A guide to the application of TBR 21

DEG/ATA-005073 (ado00icq.PDF)

PSTN, Terminal

This ETSI Guide (EG) has been produced by ETSI Project Analogue Terminals and Access (ATA).

Figure 6: Voltage level in a 10 Hz bandwidth

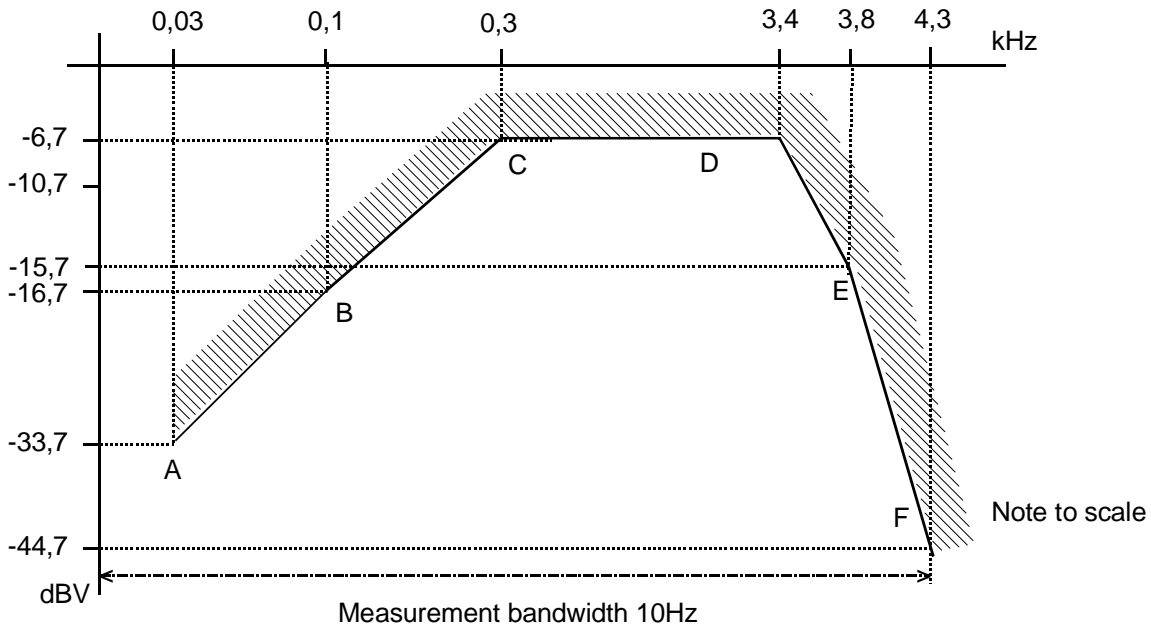
NOTE: The following requirement is a change in a the requirement of CTR 21 Clause 4.7.3.3. The changes introduced by this Advisory Note replace Table 6 of TBR 21 by Table 3 of TBR 15. Accordingly to this changes the corresponding Figure is adapted.

Requirement: The voltage within a 10 Hz bandwidth centered at any point in the frequency band 30 Hz to 4 300 Hz, and wholly contained within that frequency band, shall not exceed the limits given in table 6 and figure 6 when the TE interface is terminated with the reference impedance Z_R . This requirement also applies to DTMF signals sent after dialling.

Points	Frequency kHz	Sending level dBV
A	0,03	- 33,7
B	0,1	- 16,7
C	0,3	- 6,7
D	3,4	- 6,7
E	3,8	- 15,7
F	4,3	- 44,7

Figure A.3.1 Transient after a change to the opposite polarity

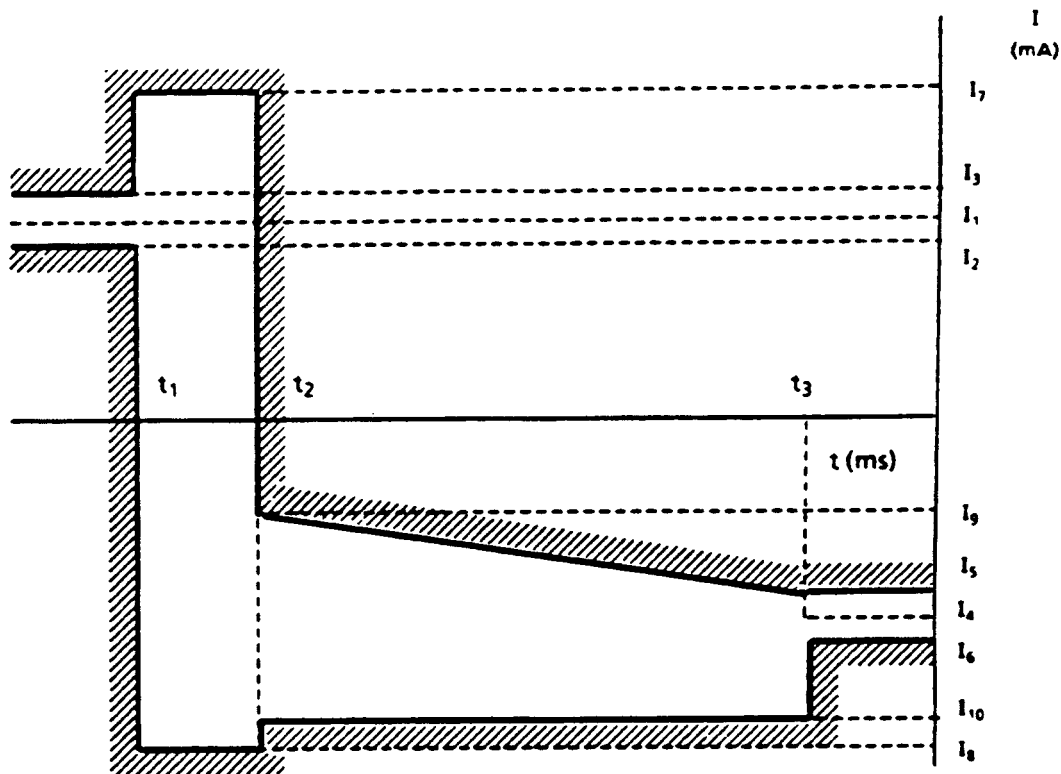
- In the Spanish PSTN, whenever a call is established, when the called TE answers the call, the network either cuts the feeding current of the calling TE for a time, or alternatively, changes the polarity of the calling TE DC feeding voltage (which also implies a little cut in the DC feeding current).
- When the DC voltage has been changed to the opposite polarity, the loop state shall be maintained within certain limits of time and current, in order not to clear the line.
- The TE must be proved capable of supporting the change to the opposite polarity in the DC voltage and the cut of the DC current without clearing the line.

Requirement: With the TE in loop condition, when it happens a change to the opposite polarity, the loop state shall be maintained in such a manner that the loop current shall comply with the limits according to the mask of figure A.3.1 where

- t_1 = instant in which the switch takes the new polarity
- $t_2 = t_1 + 3 \text{ ms}$
- $t_3 = t_1 + 10 \text{ ms}$
- I_1 = Stationary value of the loop current for the original polarity
- $I_2 = I_1 - 3 \text{ mA}$
- $I_3 = I_1 + 3 \text{ mA}$
- I_4 = Stationary value of the loop current for the new polarity
- $I_5 = I_4 + 3 \text{ mA}$
- $I_6 = I_4 - 3 \text{ mA}$
- $I_7 = 125 \text{ mA}$
- $I_8 = -125 \text{ mA}$
- $I_9 = -16 \text{ mA}$
- $I_{10} = -100 \text{ mA}$

Figure 5: TE voltage/current characteristics

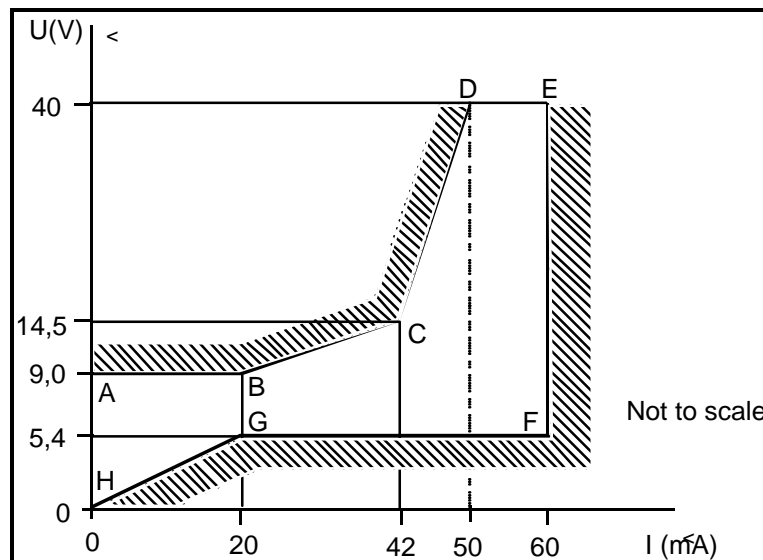
The voltage/current characteristics of TE in the loop state shall provide a minimum voltage as described in Appendix A of this Advisory note.

Requirement: The DC voltage/current characteristics of the TE within the operating range as stated in clause 4.7 shall not exceed the limits given in table 5 and shown in figure 5.

Point	Voltage (V)	Current (mA)
A	9,0	0
B	9,0	20,0
C	14,5	42,0
D	40,0	50,0
E	40,0	60,0
F	5,4	60,0
G	5,4	20,0
H	0	0
NOTE:	Limits for intermediate currents can be found by drawing a straight line between the break points on a linear voltage/current scale.

Figure 8: Output Signal Balance and Longitudinal Conversion Loss, minimum values.

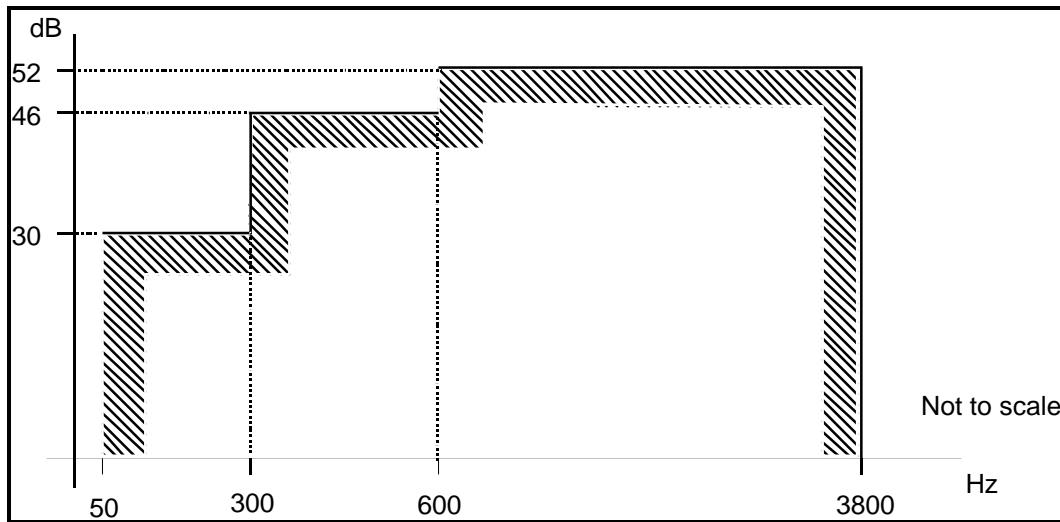
The output signal balance in Table 8 of paragraph 4.7.4.2 of prTBR 21 shall be modified as described in Appendix A of this Advisory Note.

Requirement: Where the supplier's instructions state that a connection to earth is intended, the Output Signal Balance when the AC termination of the TE is $600\ \Omega$ shall be at least the values given in table 8 and figure 8. This requirement only applies at frequencies where the unbalance level exceeds $-70\ \text{dBV}$ with the test method shown in clause A.4.7.4.2.

Frequency range	Minimum value
50 Hz to 300 Hz	30 dB
300 Hz to 600 Hz	46 dB
600 Hz to 3800 Hz	52 dB
